SHOP DRAWING

Project Title
AL WAHA RESIDENCE 01
EXPO CITY DUBAI

Drawing Title
PHASE-01 - MOBILITY DISTRICT
TYPICAL KITCHEN - DETAIL (TYPE- C1)
KITCHEN SECTIONAL PLAN
(SHEET- 3 OF 3)

Drawing No
C5128-SDW-2TR5600-FO-6000004

A 6000004 SECTION PLAN
SCALE - 1:20

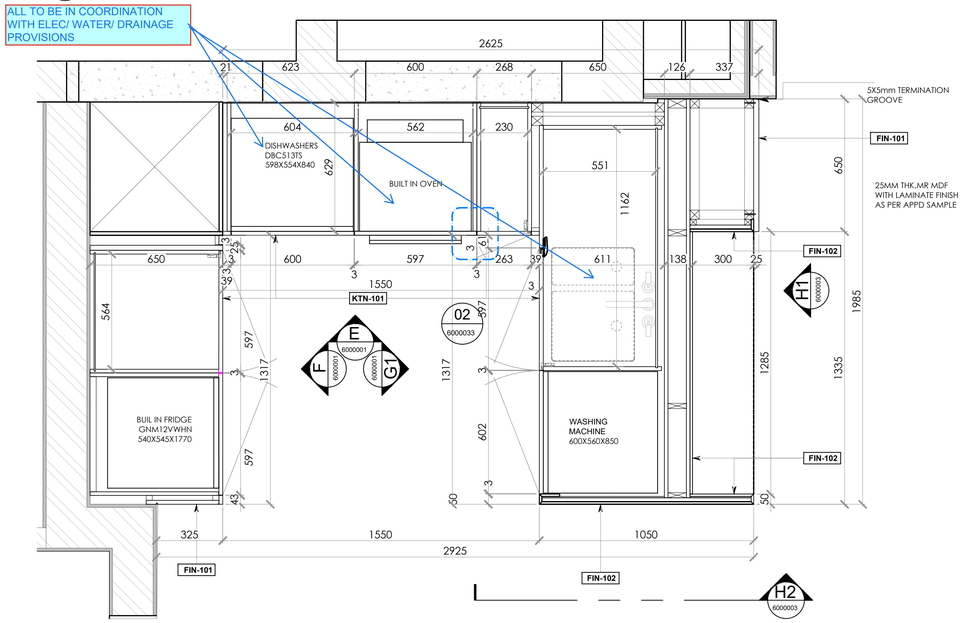
SECTION CALL-OUT INCORRECT

ALL TO BE IN COORDINATION WITH ELEC/ WATER/ DRAINAGE PROVISIONS

C 6000004 SECTION PLAN
SCALE - 1:20

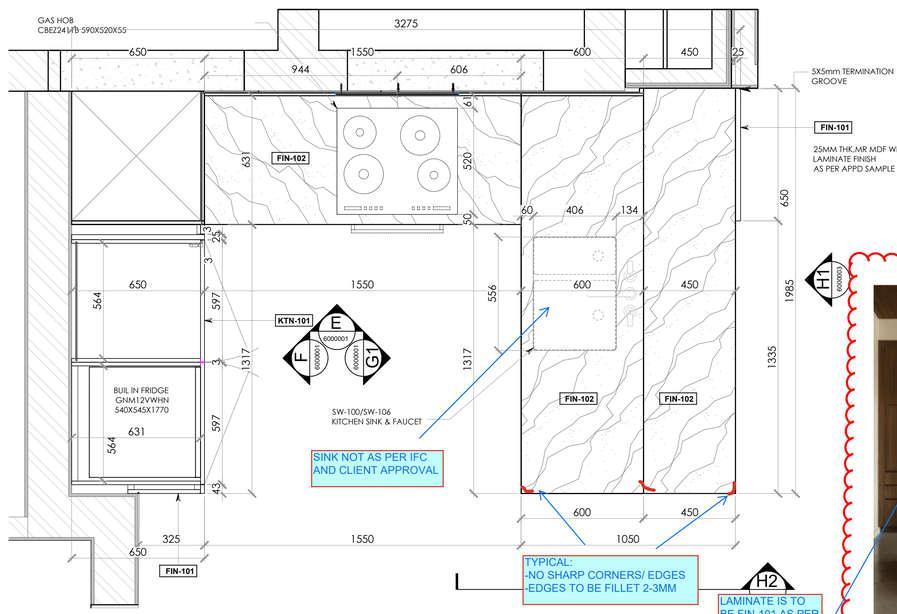
TYPICAL:
-NO SHARP CORNERS/ EDGES
-EDGES TO BE FILLET 2-3MM

LAMINATE IS TO BE FIN-101 AS PER SPEC'S, PROJ. REPORT (C3079-RPT-2TR5600-AR-0000006(A)), & IFC DRAWINGS

-6MM BACK PANEL NOT ACCEPTABLE

-9MM TO BE PROPOSED SIMILAR TO WARDROBES APPROVED VE APPENDIX 2

-SUBJECT TO COST SAVING
